Lycoming Piston Engines

**AD/LYC/101**  
**Amdt 1**

**Superior Cylinders**

**3/97**

FIGURE 1

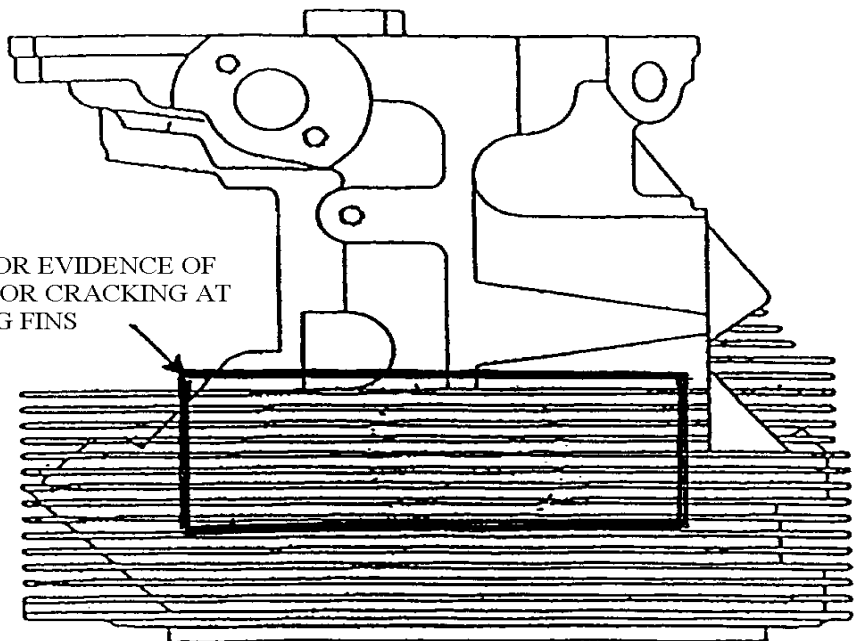
- Requirement:
1. To prevent the possible loss of a cylinder head, the subsequent loss of engine power and a possible engine fire, carry out:
    - a. A visual inspection of applicable cylinder assemblies for evidence of combustion leaks and/or cracking in the area adjacent to the location of the inlet valve seat as detailed in Figure 1, and
    - b. An 80psi pressure “wet” leak check of the cylinder assemblies paying particular attention to the area detailed in Figure 1.

INSPECT MARKED AREA FOR EVIDENCE OF COMBUSTION LEAKS AND/OR CRACKING AT THE BASE OF THE COOLING FINS

Remove from service before further flight, any cylinder showing either combustion gas leakage or cracks.
